Access Compliance Report

Public Rights-of-Way

(Pedestrian Signals)

Intersection ID: N/A	Main Street:	Cross Street: N/A	Location: N/A
ADA ID: 0A72A622B602	Signal Type: One Push Button-Non APS	Overall Compliance: No	Severity Score: BTN 1: N/A BTN 2: N/A No BTN: N/A
Codes/Mitigation Info/Possible Solution		Field Measurements/Component Compliance

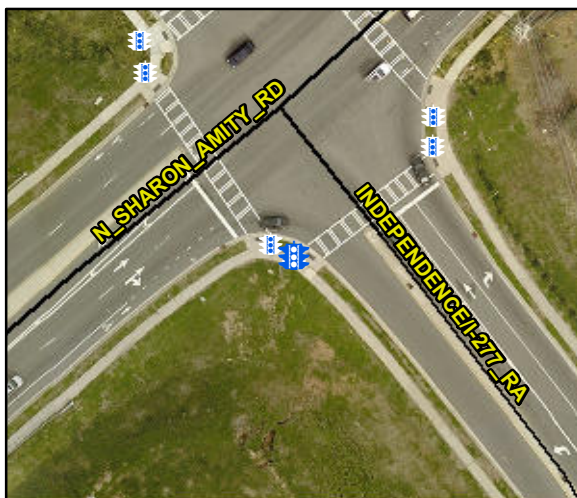
PROW/ADA: , R404.2, R404.3, R406.2

Compliance	Description	Data	Compliance	Description	Data
	Button Count	Button1	No	Distant to Additional Button (in)	102.0
	Additional Button Present?	Yes		Additional Button ID	AE371676C698
N/A	Signal Buttons Required?	N/A	N/A	Additional Ped Posts Required	N/A
	How Many Ped Street Xings?	1		Located In An Island/Median?	No
N/A	B 1 Sign Present?	Yes	N/A	B 2 Sign Present?	N/A
Yes	B 1 Sign Purpose?	Yes	N/A	B 2 Sign Purpose?	N/A
Yes	B 1 Sign Lettering & Contrast?	Yes	N/A	B 2 Sign Lettering & Contrast?	N/A
Yes	B 1 Parallel To XWalk?	Yes	N/A	B 2 Parallel To XWalk?	N/A
Yes	B 1 PAR to Button?	Yes	N/A	B 2 PAR to Button?	N/A
Yes	B 1 PAR to XWalk?	Yes	N/A	B 2 PAR to XWalk?	N/A
Yes	B 1 Clear Floor Space?	Yes	N/A	B 2 Clear Floor Space?	N/A
N/A	B 1 FWD Approach?	Yes	N/A	B 2 FWD Approach?	N/A
N/A	B 1 FWD Approach Constrained?	No	N/A	B 2 FWD Approach Constrained?	N/A
No	B 1 FWD Approach Reach (in)	5.0	N/A	B 2 FWD Approach Reach (in)	N/A

N/A	B 1 FWD Approach Width (in)	N/A	N/A	B 2 FWD Approach Width (in)	N/A
N/A	B 1 FWD Approach Obstruction?	Yes	N/A	B 2 FWD Approach Obstruction?	N/A
N/A	B 1 FWD Approach Obstruction Dist (in)	3.0	N/A	B 2 FWD Approach ObstructionDist (in)	N/A
N/A	B 1 PARA Approach?	Yes	N/A	B 2 PARA Approach?	N/A
N/A	B 1 PARA Approach Constrained?	No	N/A	B 2 PARA Approach Constrained?	N/A
Yes	B 1 PARA Approach Reach (in)	5.0	N/A	B 2 PARA Approach Reach (in)	N/A
N/A	B 1 PARA Approach Width (in)	N/A	N/A	B 2 PARA Approach Width (in)	N/A
N/A	B 1 PARA Approach Obstruction?	Yes	N/A	B 2 PARA Approach Obstruction?	N/A
N/A	B 1 PARA Approach Obstruction Dist (in)	3.0	N/A	B 2 PARA Approach ObstructionDist (in)	N/A
No	B 1 Clear Floor Space Slope (%)	4.7	N/A	B 2 Clear Floor Space Slope (%)	N/A
No	B 1 Clear Floor Space XSlope (%)	5.5	N/A	B 2 Clear Floor Space XSlope (%)	N/A
N/A	B 1 PAR Slope (%)	0.9	N/A	B 2 PAR Slope (%)	N/A
Yes	B 1 Height (in)	41.0	N/A	B 2 Height (in)	N/A

Possible Solutions: Replace Signal Push Button With APS Button on New Post. Remove & Relocate Sign.
